Maule Aircraft Corporation

SERVICE LETTER # 40

Subject: Flap Placard

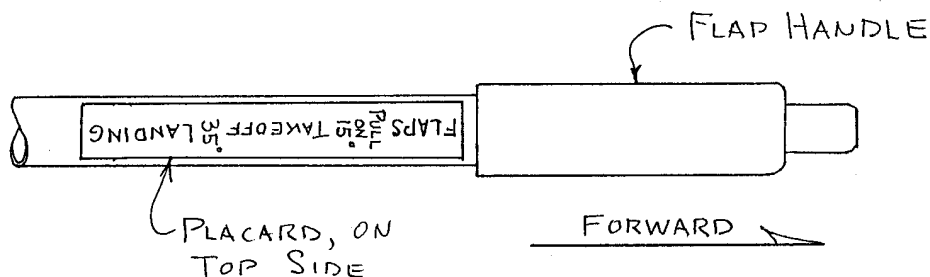
Background: A placard is required on the flap handle, and it is possible that this placard was left off of some of these airplanes.

If it does not have this placard, make sure the upper surface of the flap handle, just aft of the grip, is clean. Peel the backing from the placard and attach the placard to the flap handle as shown in the sketch.
